**CONTRACT :** Plot 18 by Dorchester Collection

**Material Description:** Material Delivery Inspection Request for Custom Fabricated Kitchen Equipment as per the attached DO No. ELE-DC-010223 and approved custom fabrication drawing.

## SHOP DRAWING

Project:	Contractor / Package	Document No.	Revision
Plot 18 by Dorchester Collection	Khansaheb Civil Engineering LLC	ELE-AX-SD-B1-01005	01
To: Khansaheb Civil Engineering	Omniyat Middle East Real Estate Development LLC	Submittal Issue Date:	29.08.2022

Authorised:-	RA		
SCALE	1:25 @ A2	DATE	09-12-2022
DRAWING NO.	ELE-AZ-SD-GF-09010	REV.	00

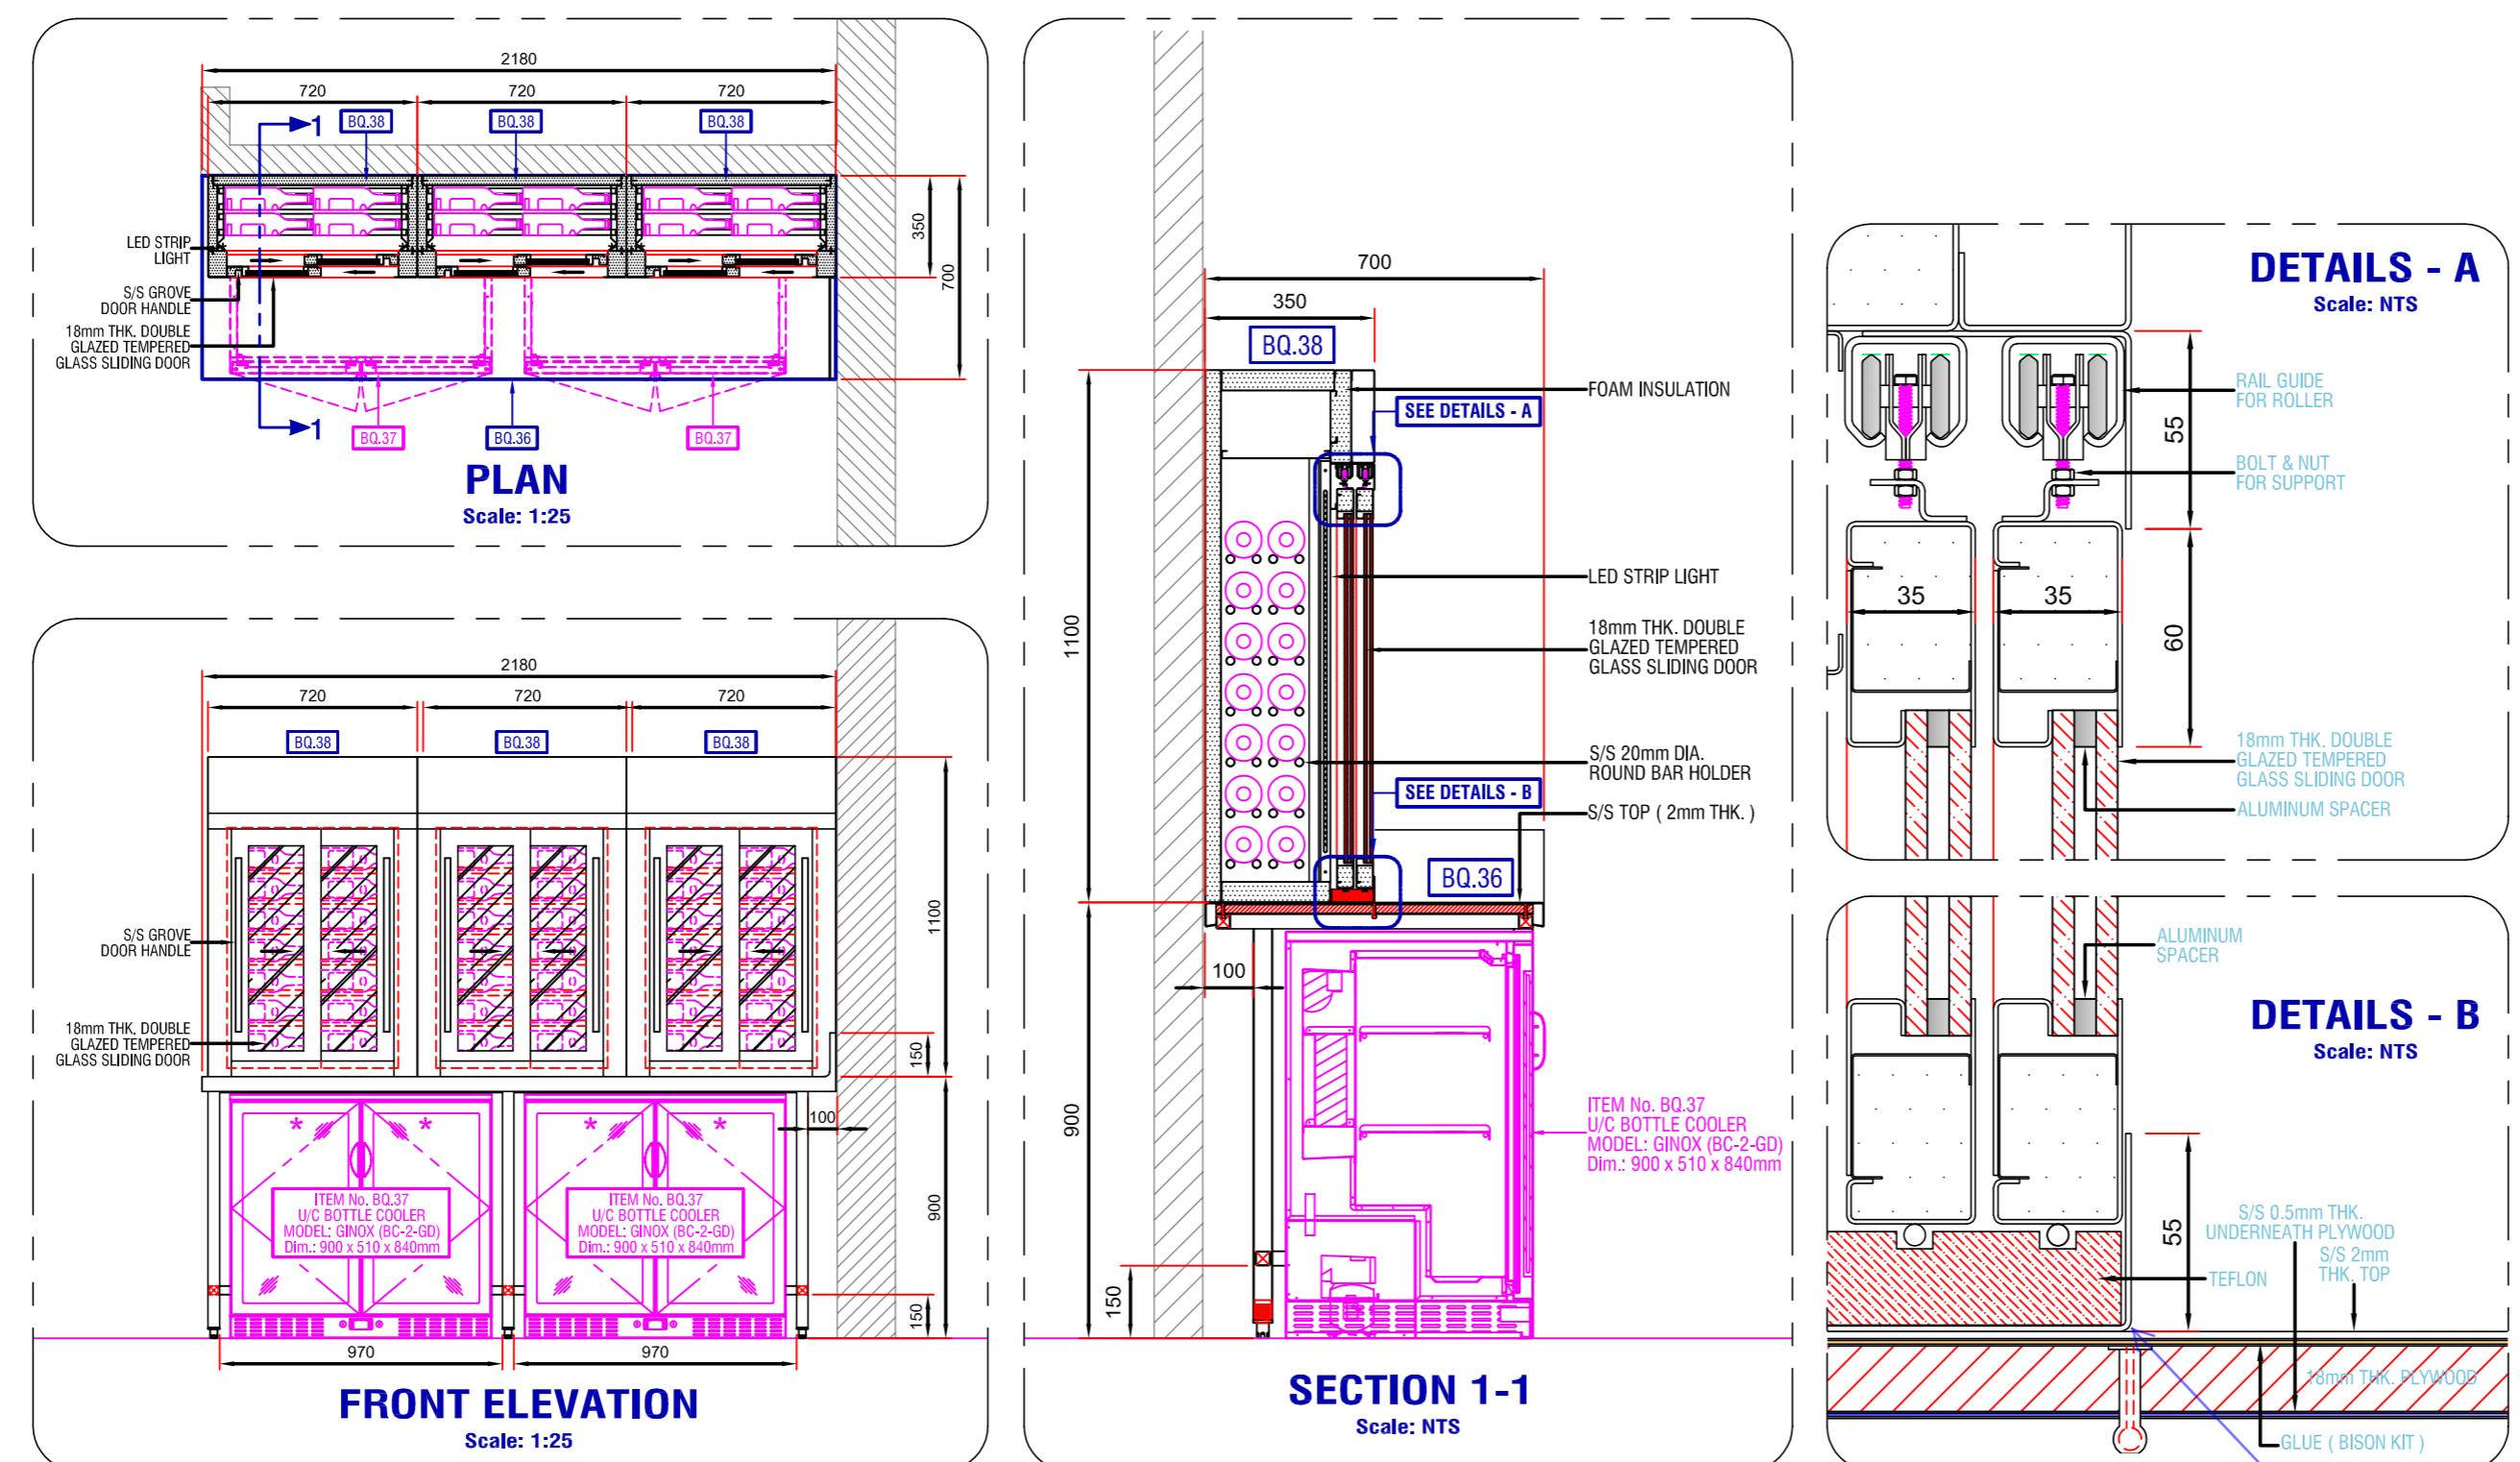
Wall and bottom mounting details to be indicated
